## **EASTSIDE BRANCH LIBRARY ACCESSIBILITY SURVEY**

**July, 2007**

**CITY OF SANTA  
BARBARA**

*Site - Photo # 4*

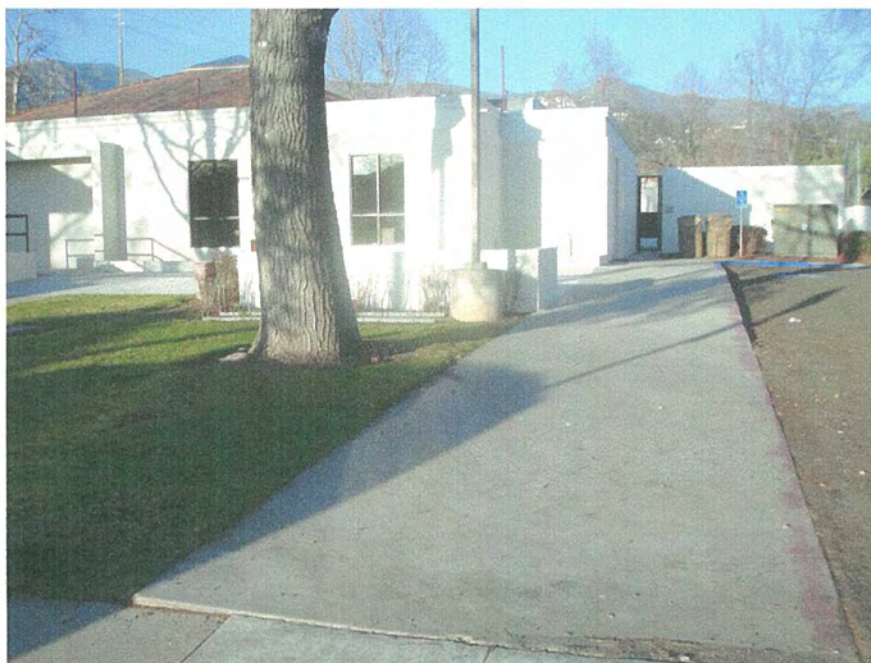
*Walk slope exceeds 5%, requiring compliant ramp handrails.*

*Building - Photo # 5*

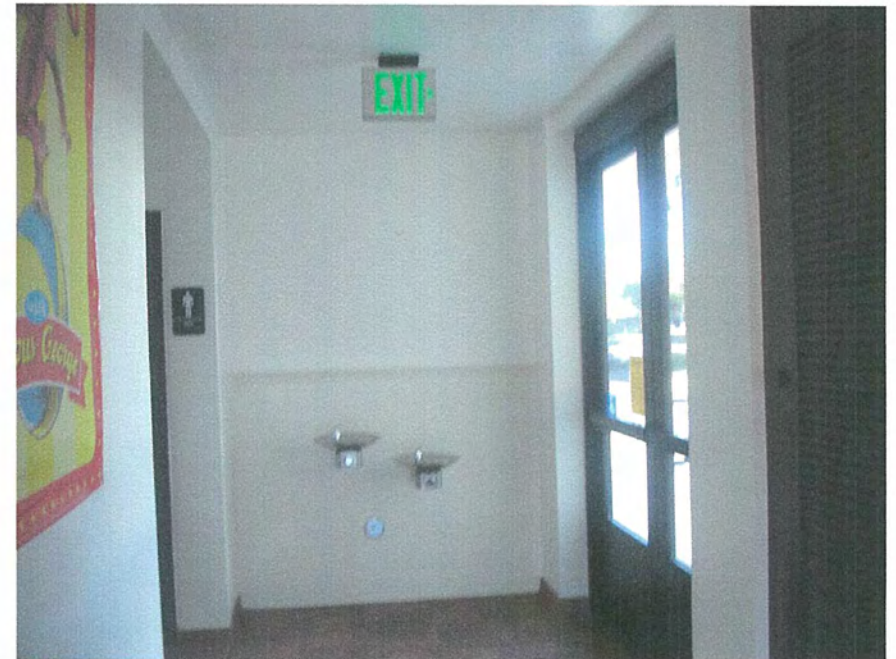
*Strobe light has red cover instead of the required white or clear cover. Fire alarm pull station requires tight grasping to operate and is mounted behind chairs.*

*Building - Photo # 11*

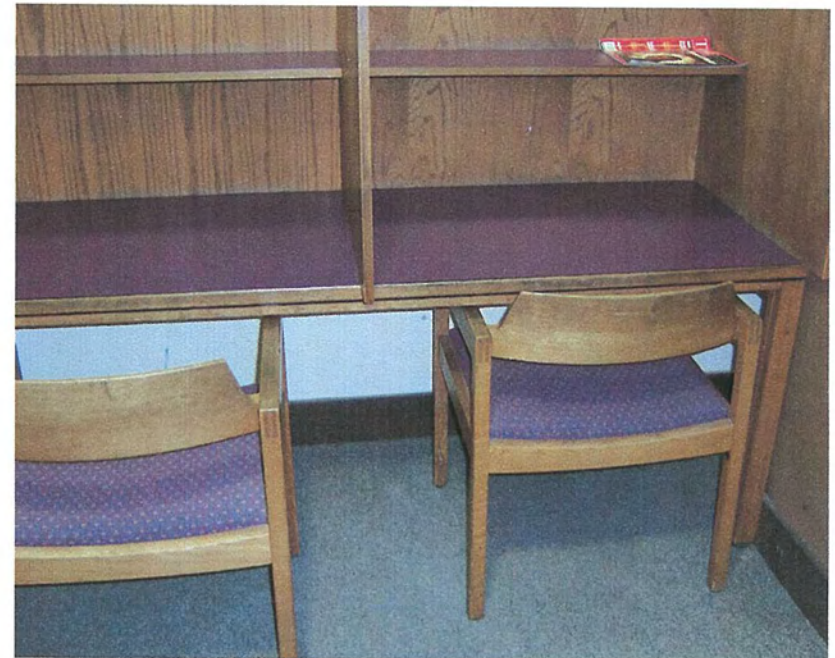
*Circulation to counter back work area is too narrow, less  
than 36" wide.*

*Building - Photo # 13*

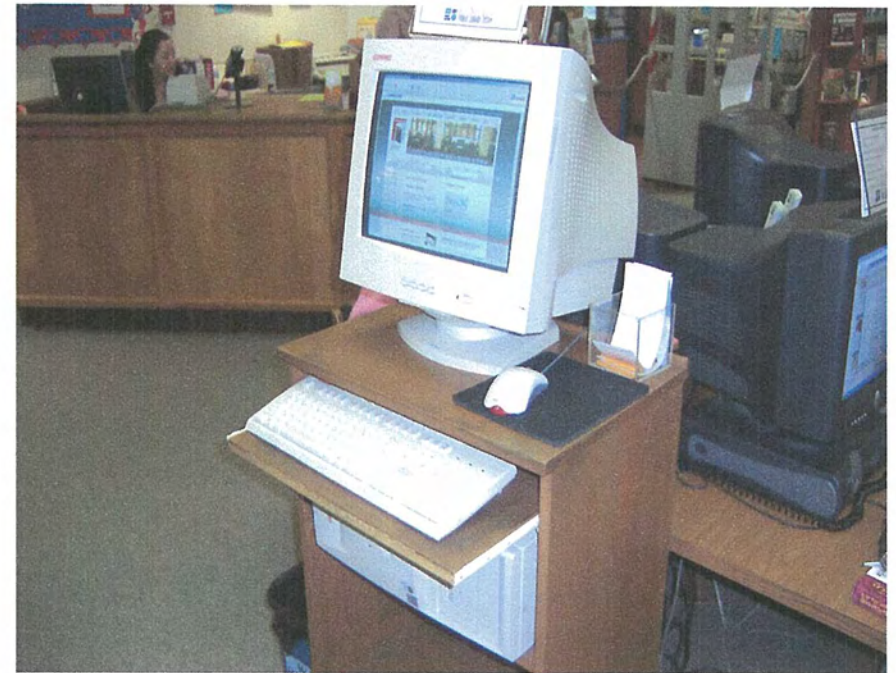
*Built-in study carrel does not have the required knee clearance.*

*Building - Photo # 15*

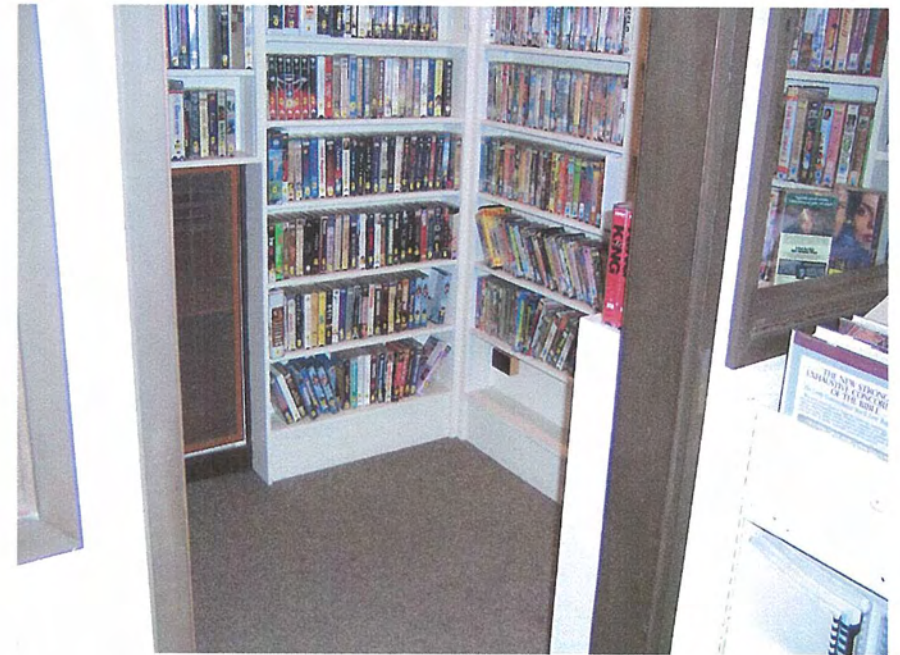
*Computer library catalog is not accessible, it does not have the required knee clearance and is mounted too high.*
